Re: Mister Car Wash 3535 Menaul NE

Albuquerque, NM 87107 Traffic Circulation Layout

Engineer's Stamp 10-10-25 (H16D083F)-TRANS-2025-00096

Re: Carlisle and Menaul

SHEET C0.0

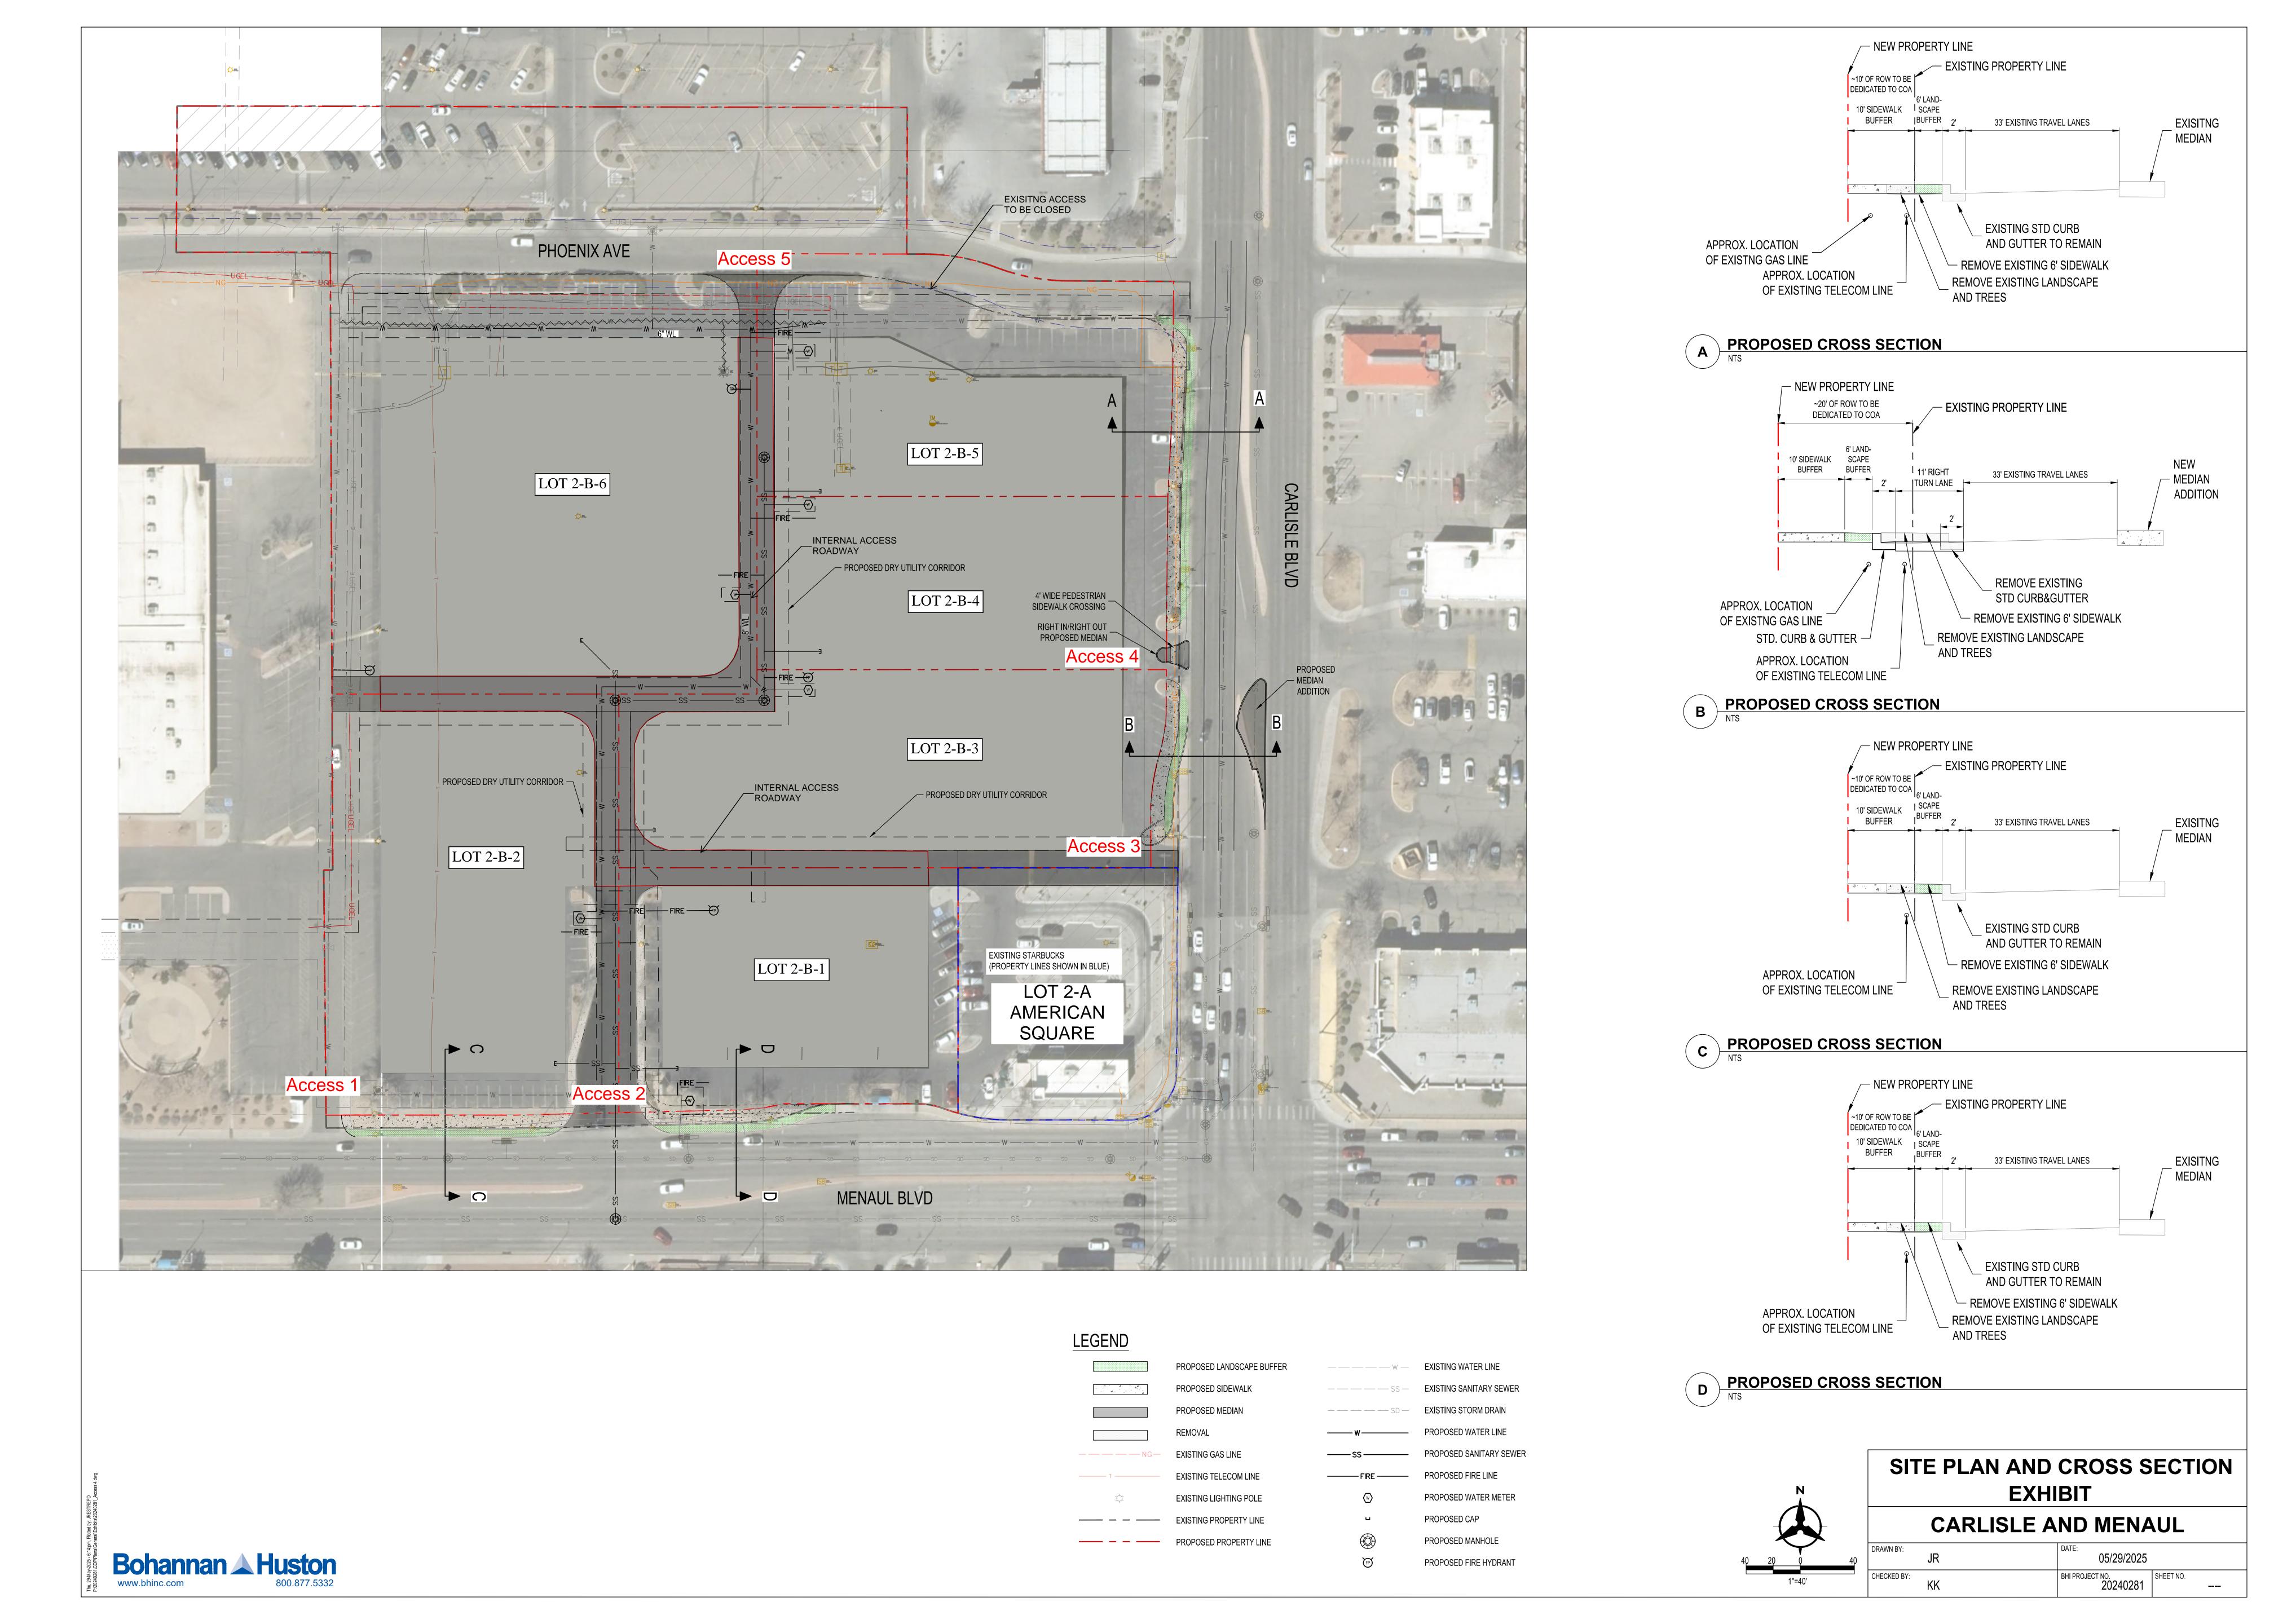
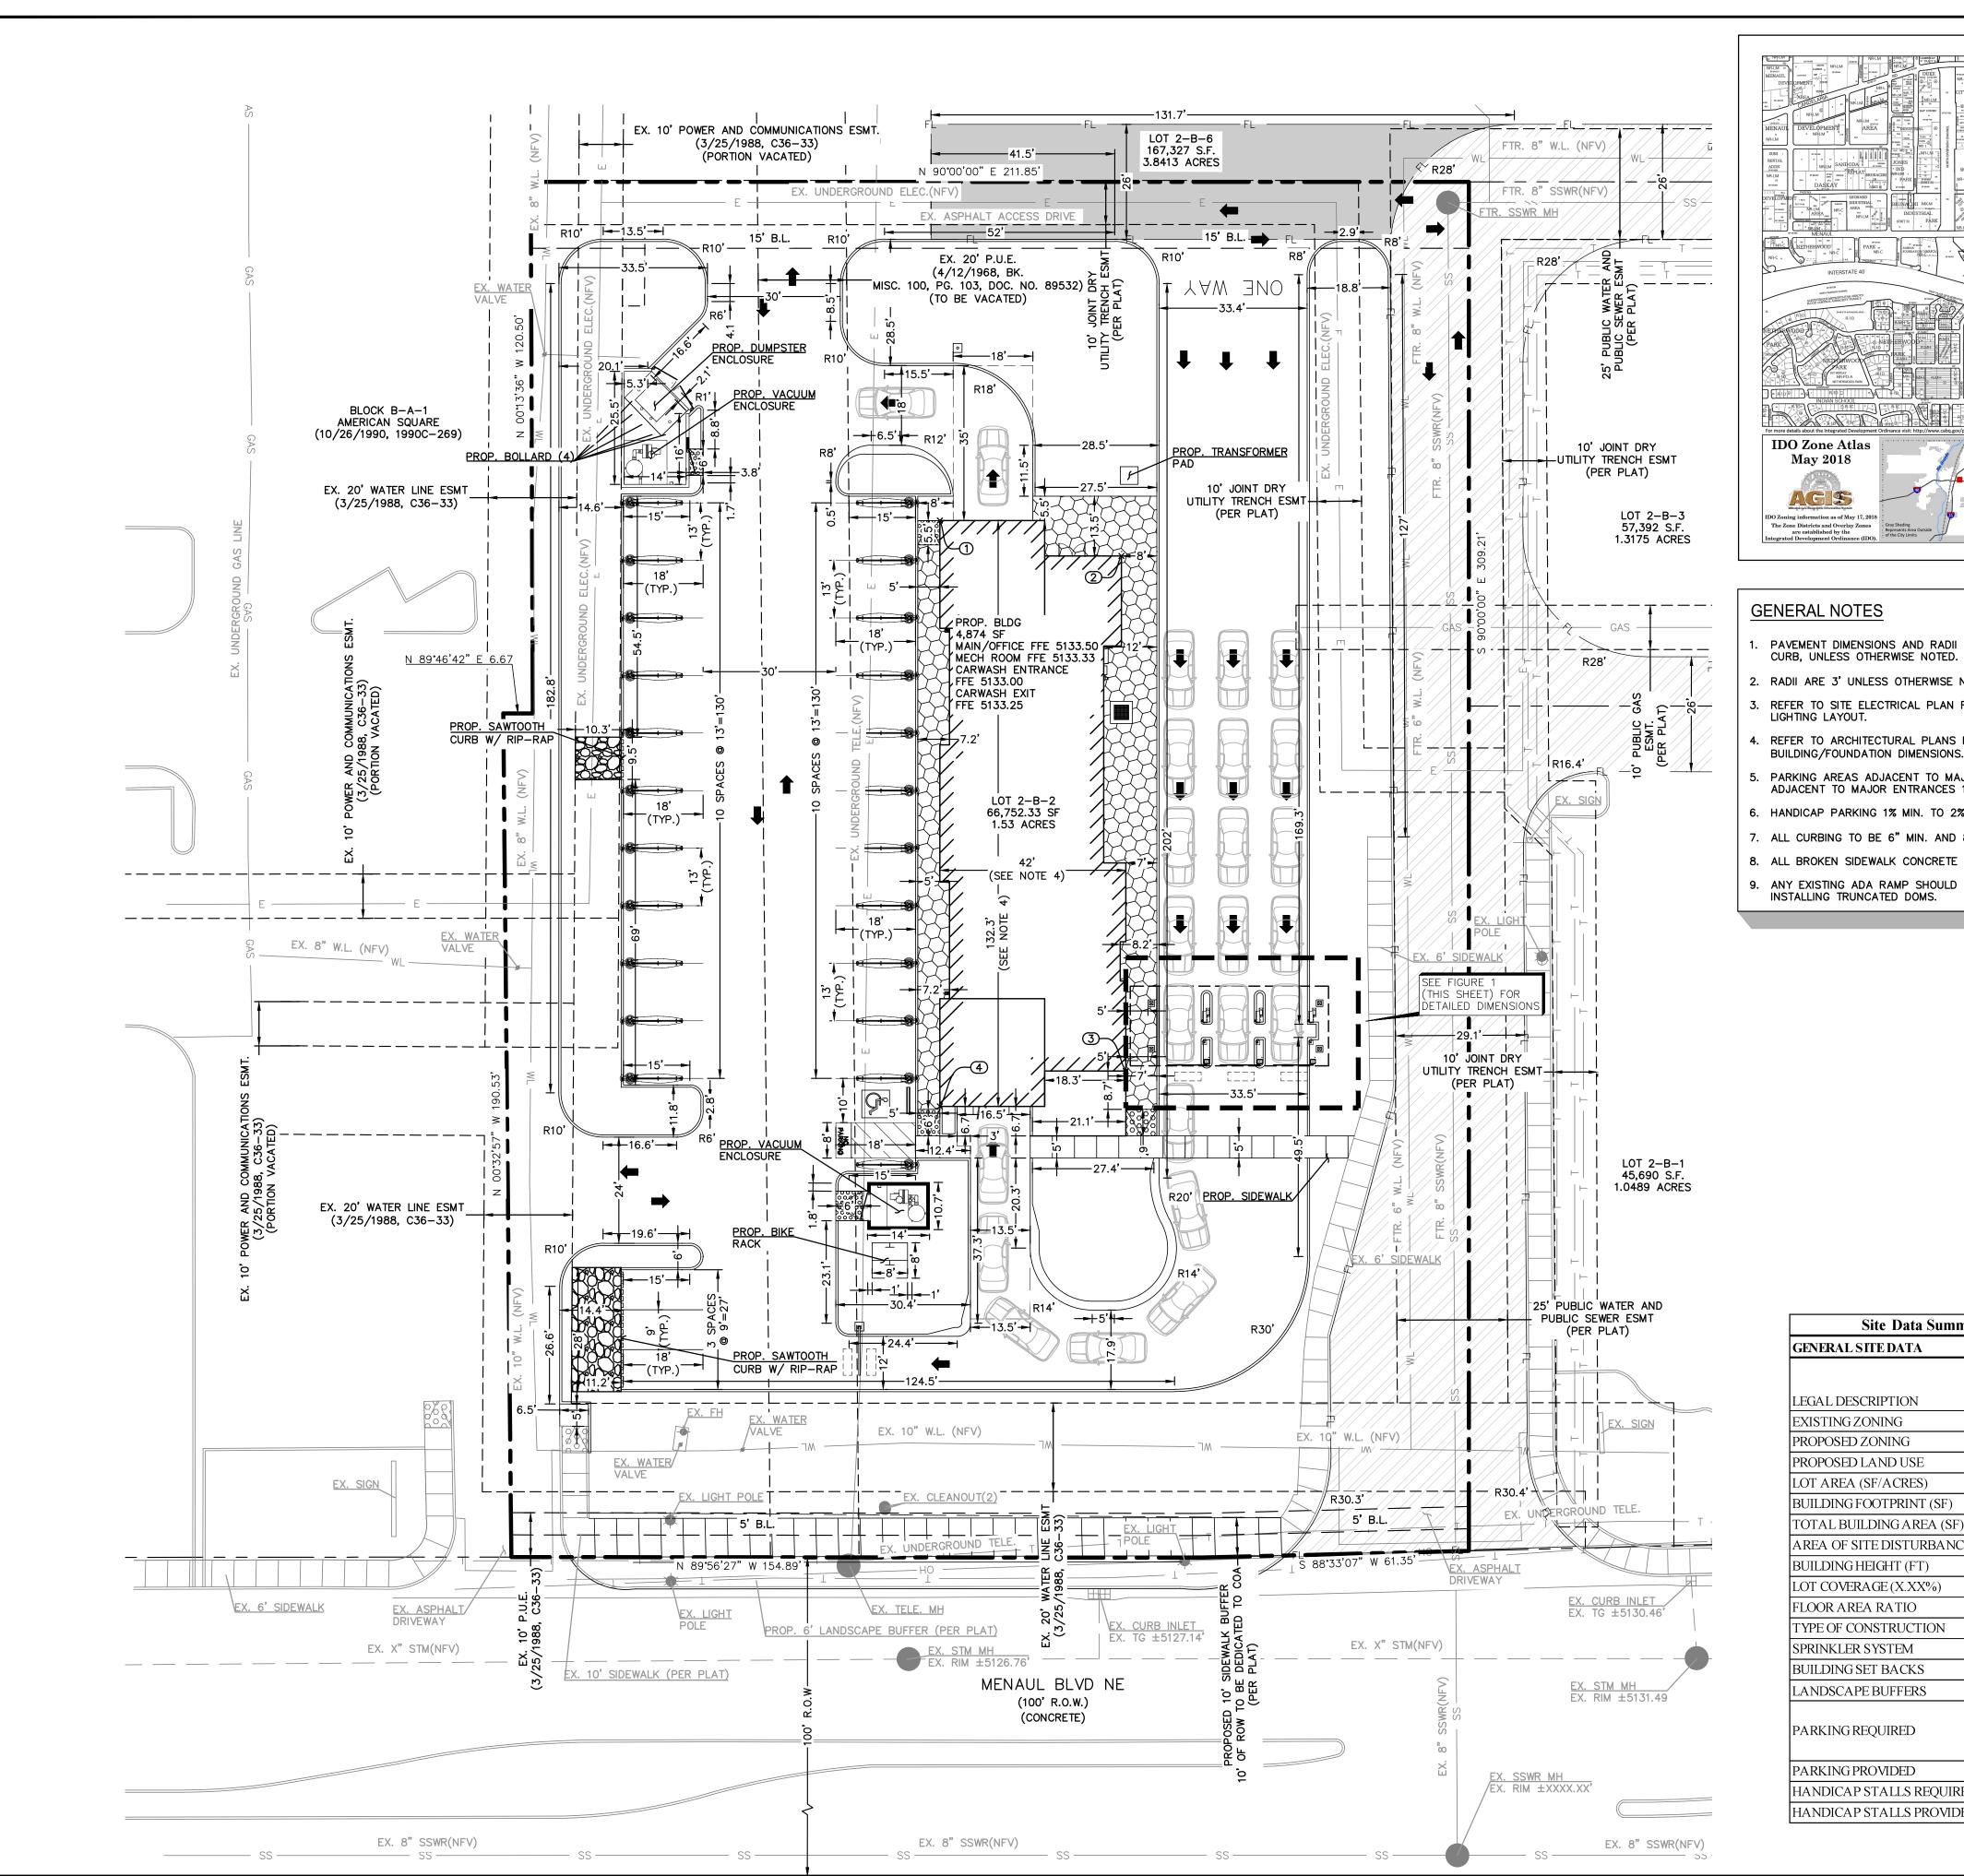
PO Box 1293 The TCL resubmittal received 10-17-25 is approved for Building Permit by Transportation. A copy

requested, use the original City stamped approved TCL for certification. Redline any minor changes and adjustments that were made in the field. A NM registered architect or engineer must stamp, sign, and date the certification TCL along with indicating that the development was built in
